Southampton to London Pipeline Project

Responses to ExA's Further Written Questions -
Suitable Alternative Natural Greenspaces (SANGS)

Application Document: 8.44

January 2020

Extract from Phase one Habitat Survey

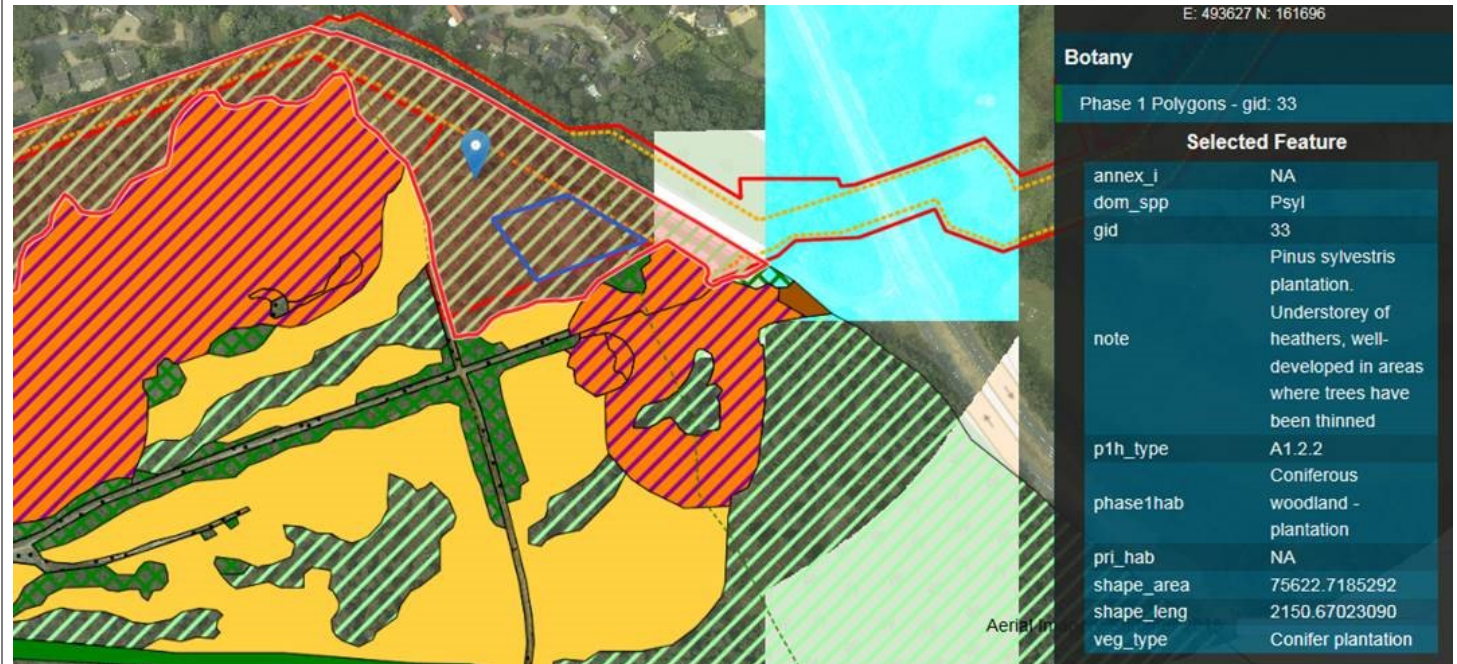
ExQ2	Question:	Applicant response to Question:
		<p>1.28 The key points are that the compound was located away from the open, wetter, heathland to the south, and that the creation of the construction compound would result in the clearance of the woodland vegetation from this area, and once the works in Turf Hill are completed, the site would be cleared and left to naturally regenerate as additional heathland in line with the objectives of the Surrey Heath Turf Hill Management Plan 2015-2025.</p> <p>1.29 This location has been discussed in site meetings with representatives of Natural England, Surrey Wildlife Trust and Surrey Heath Borough Council and no concerns were raised.</p> <p>1.30 The evidence for the position of the Applicant can be found in the photograph below showing the location of the compound, and the extract below that from the phase one habitat survey identifying the site (blue edge) as a coniferous woodland plantation in the text on the right of the image.</p> <p>Photograph of Compound location west of Guilford Road</p>
